Access Compliance Report

Public Rights-of-Way

(Curb Ramps)

Intersection ID: 16298	Main Street: W_TYVOLA_RD	Cross Street: YORKMONT_RD	Location: NW
ADA ID: 38B79BE0C531	Ramp Type: Perp	Initial Pass/Fail: Fail	Overall Compliance: No
Codes/Mitigation Info/Possible Solution		Field Measurements/Component Compliance	
Severity Score: 10

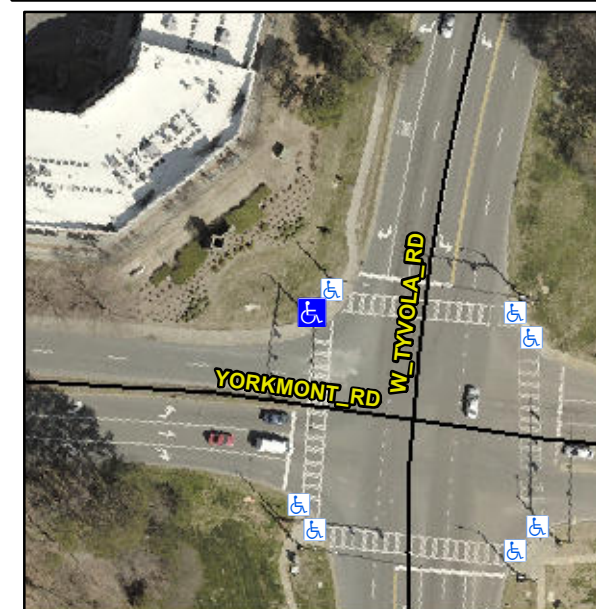
Not Found, R304.5.1

Compliance	Description	Data	Compliance	Description	Data
N/A	Ramp Length (in)	59.5	Yes	Ramp Slope (%)	7.1
No	Ramp Width (in)	46.0	Yes	Ramp XSlope (%)	4.8
N/A	Flare Type LT	N/A	N/A	Flare Type RT	N/A
N/A	Flare Slope LT (%)	N/A	N/A	Flare Slope RT (%)	N/A
N/A	Flare Traversable LT?	N/A	N/A	Flare Traversable RT?	N/A
N/A	Landing Length (in)	N/A	N/A	DWS Provided?	N/A
N/A	Landing Width (in)	N/A	N/A	DWS Contrast?	N/A
N/A	Landing Slope (%)	N/A	N/A	DWS Length (in)	N/A
N/A	Landing X Slope (%)	N/A	N/A	DWS Full Width?	N/A
N/A	Landing Curb? (Y/N)	N/A	N/A	DWS Offset (in)	N/A
N/A	Shared Landing?	N/A			
N/A	Gutter Ponding?	N/A	N/A	Gutter Slope (%)	N/A
N/A	Gutter Lip Ht (in)	N/A	N/A	Gutter X Slope (%)	N/A
N/A	Painted X Walk1?	Yes	N/A	Painted X Walk2?	N/A
	X Walk 1 Direction	To S		X Walk 2 Direction	N/A
N/A	X Walk 1 Width (in)	107.0	N/A	X Walk 2 Width (in)	N/A
	X Walk 1 Slope (%)	0.6		X Walk 2 Slope (%)	N/A
	X Walk 1 X Slope (%)	5.7		X Walk 2 X Slope (%)	N/A

Remove & Replace Entire Ramp.
